Delegated Report

Prior Approval Extensions Application

Application no:	20240612
Location	4 Harden Road Northfleet Gravesend Kent
Proposal:	Prior approval application for a single storey rear extension with a depth of 6.00 metres, maximum height of 3.60 metres and eaves height of 3.00 metres.
Applicant:	Mr Ivan Chavdarov
Site Visit	N/A Desktop Assessment

Existing Dwellinghouse	Proposed Extension
------------------------	--------------------

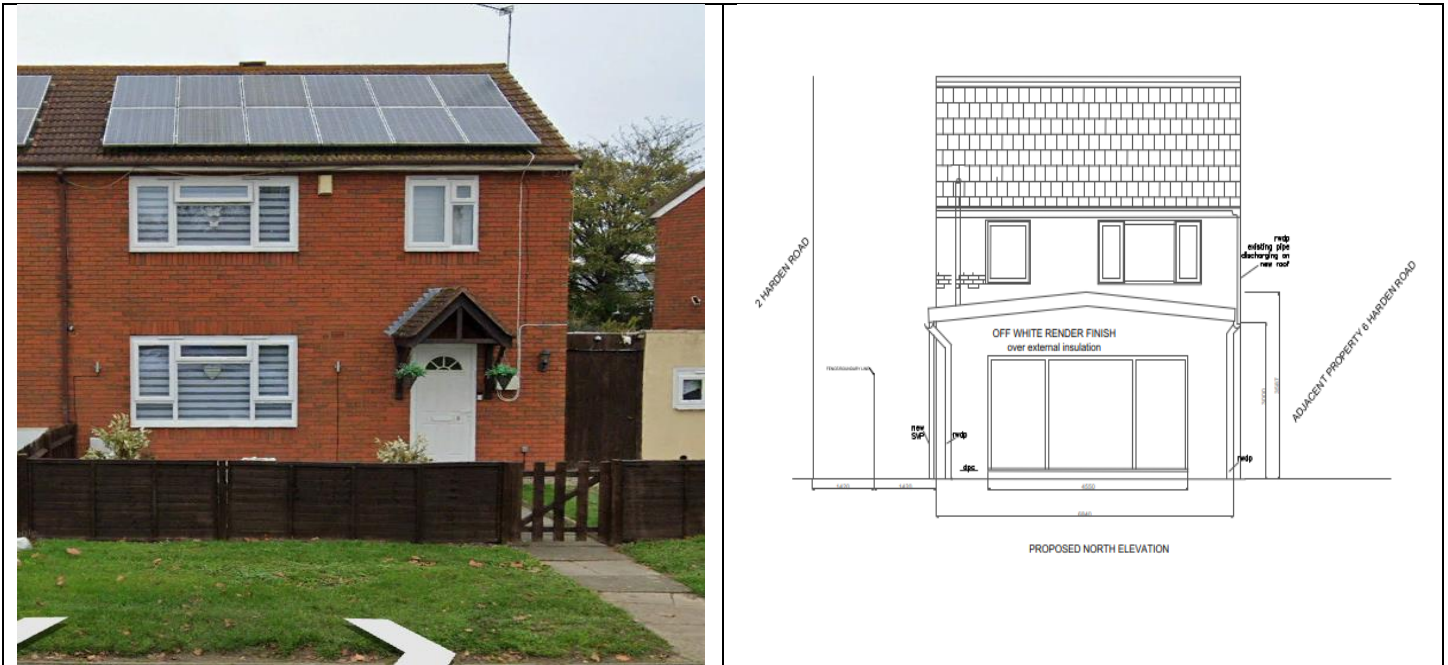
The plans show the proposal would fail to comply with A.3 (a), as the proposed materials are not similar in appearance to the exterior of the existing dwelling. As shown below, the development proposes to be constructed with a white rendered finish which is not considered to be of a similar appearance to the red brick of the existing dwellinghouse:

The information provided, shows the proposed development fails under Class A. .3 (a) as the proposed exterior finish does not match that of the existing dwellinghouse.
